**HMC ARCHITECTS
3546 Concourses Street
Ontario, California 91764**

Arvin High School ESSER III Phase 1 Roofing

Kern High School District

File No: 15-H3 A#03-122508

A4.31 BUILDING 2A & 2B – ROOF PLAN – REMODEL. Dated 2023.09.18

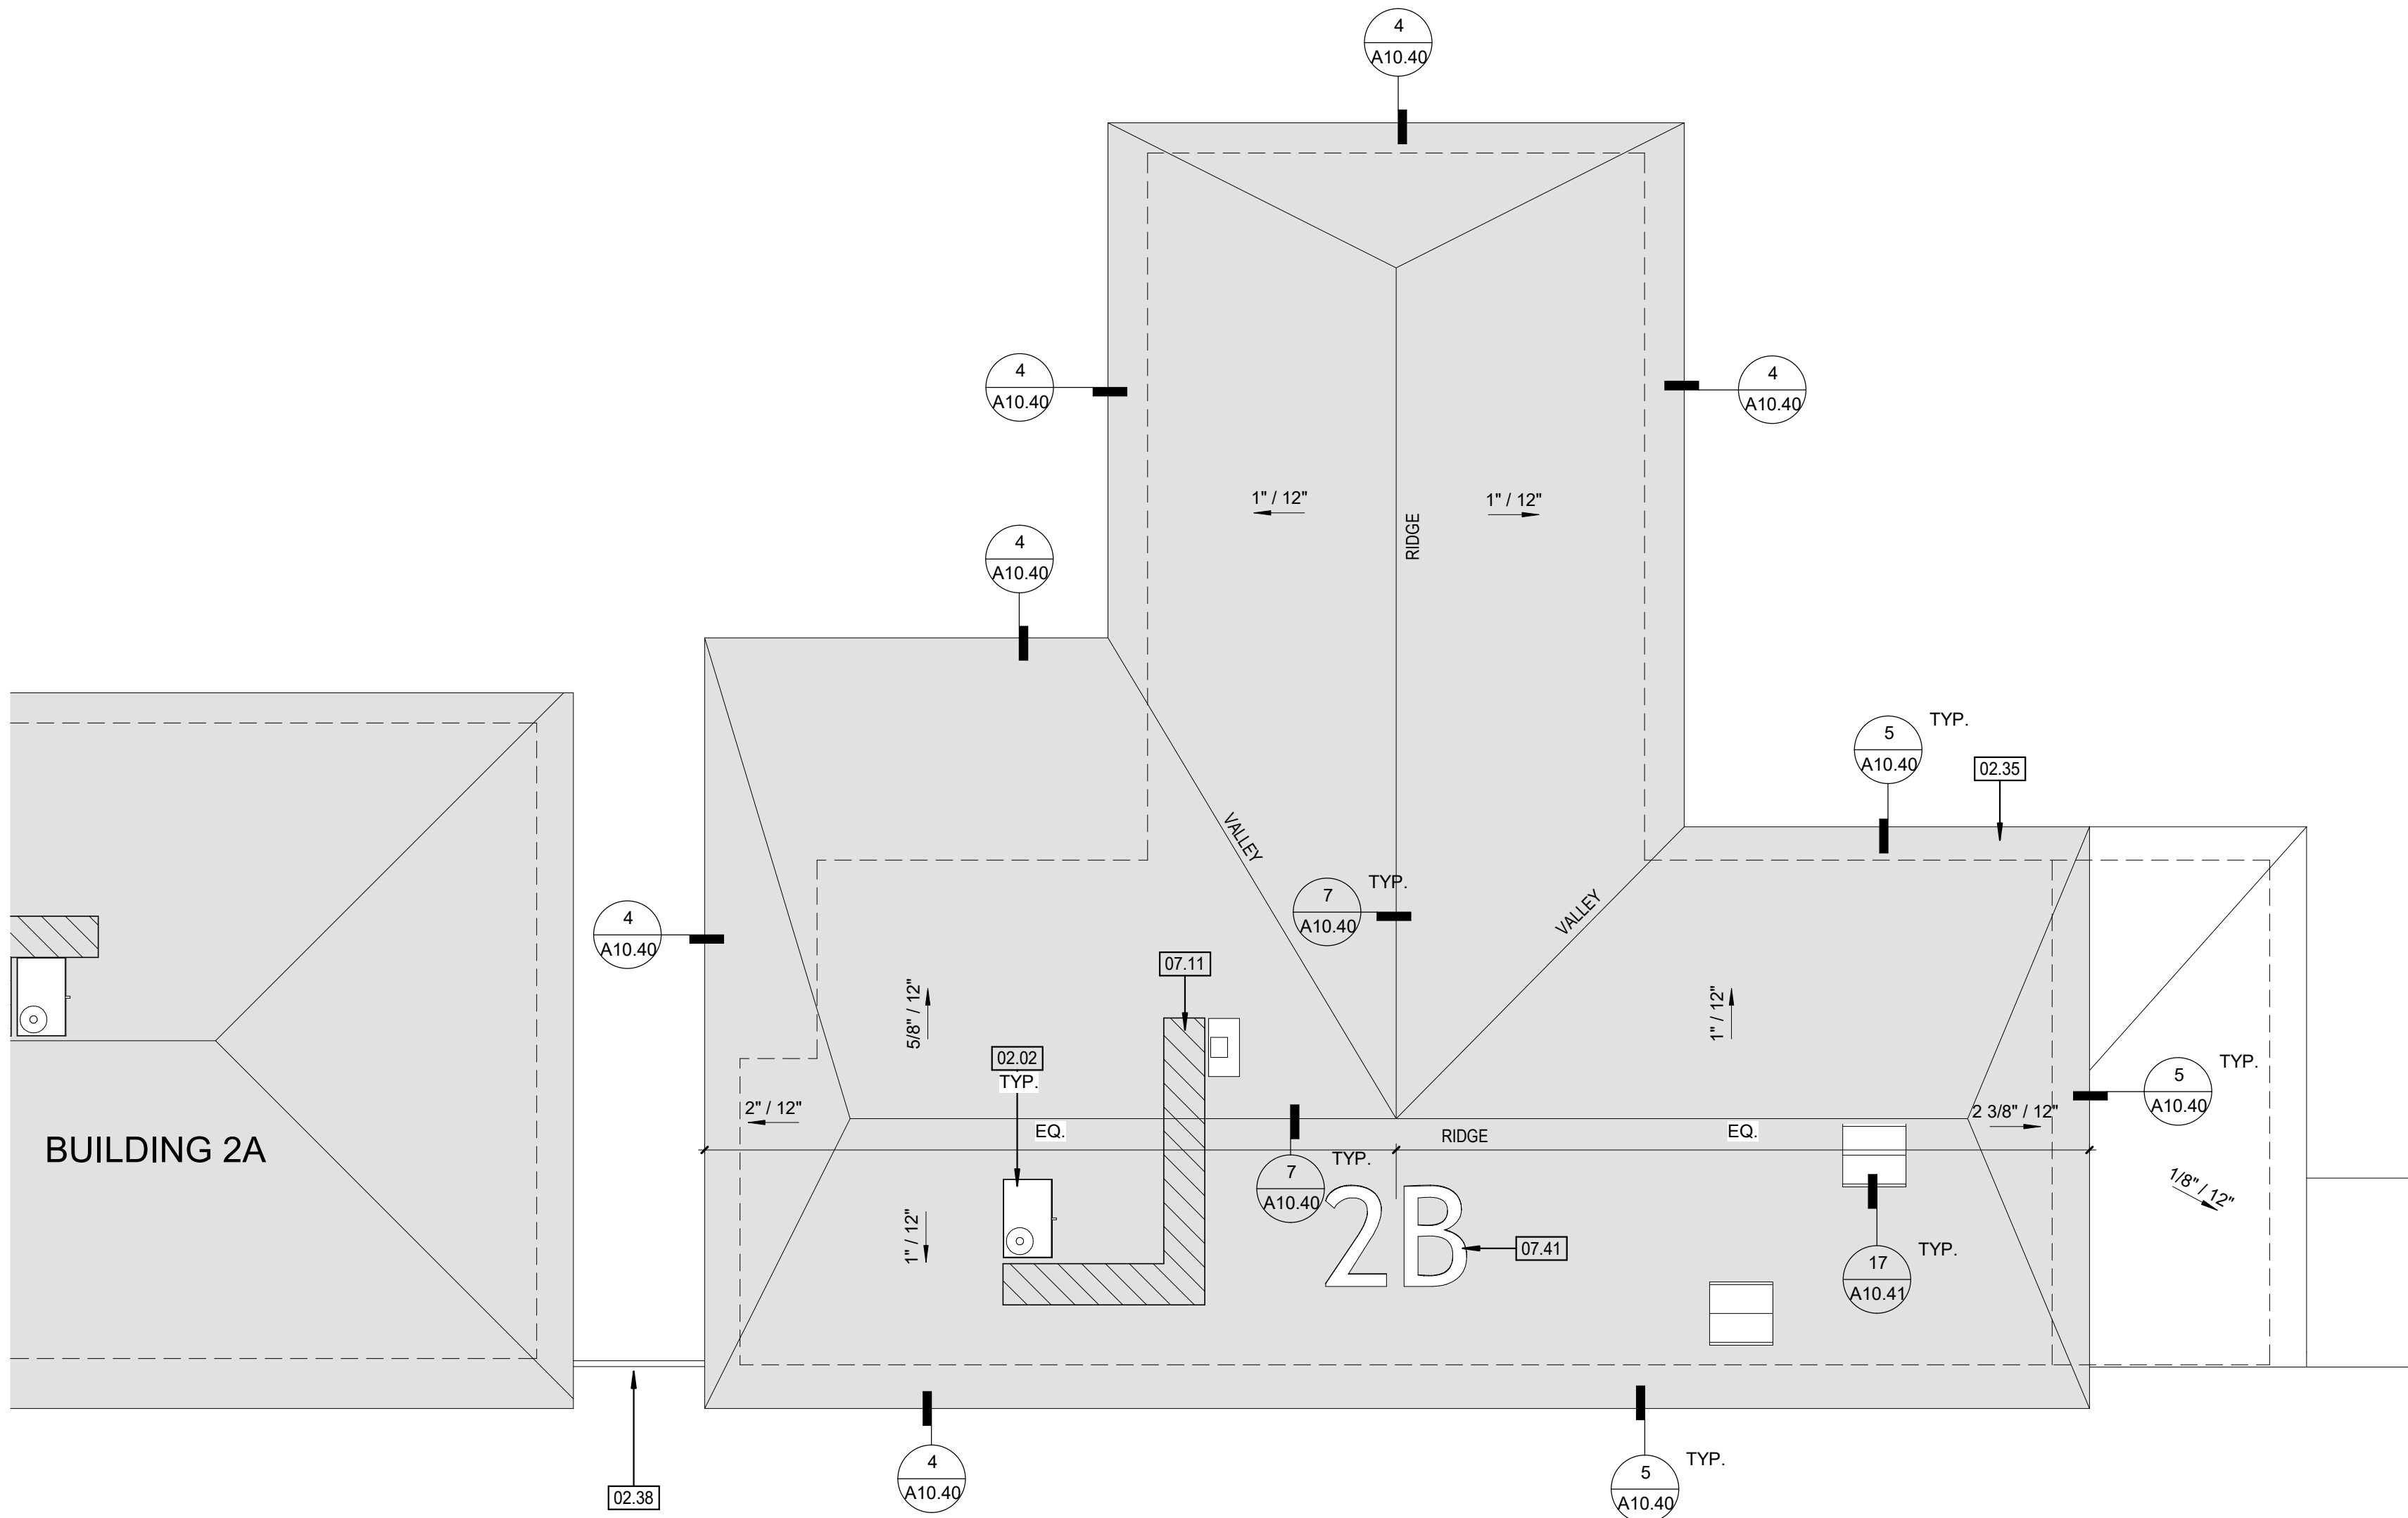
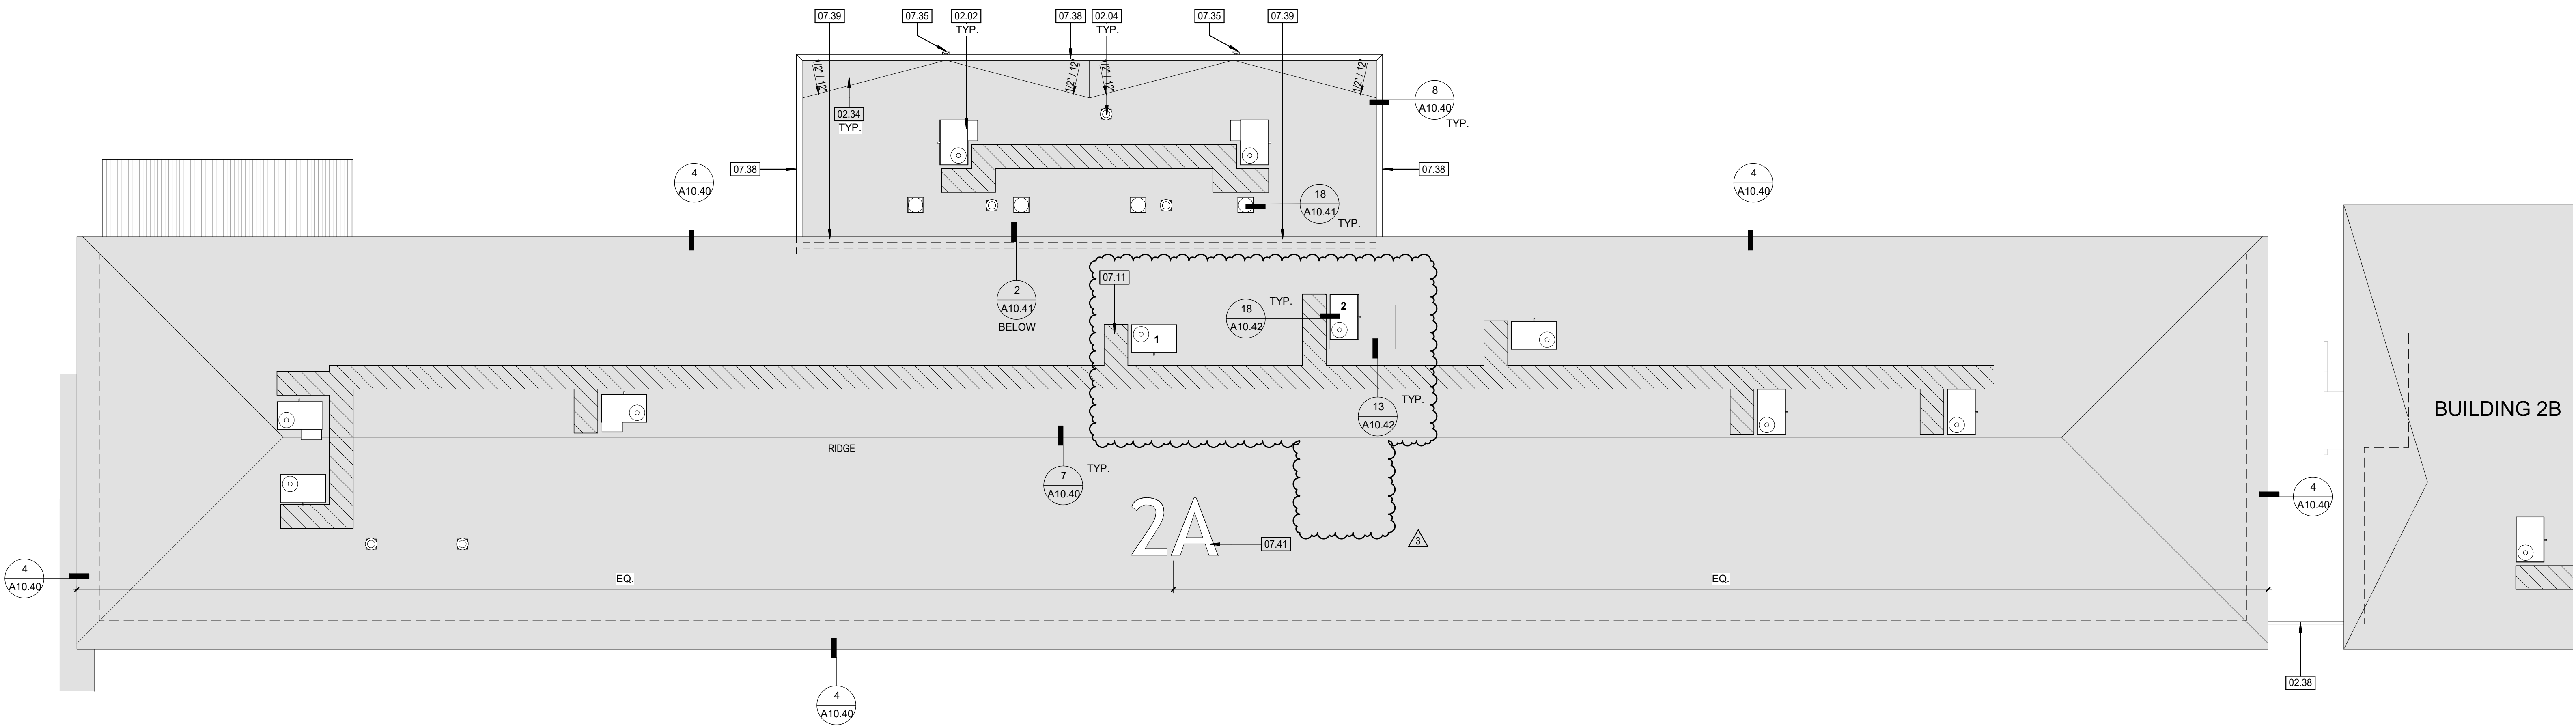
- A. At 1/A4.31 – Bldg 2A – Roof Plan – Remodel, ADD Details References as shown and clouded per Delta 3.
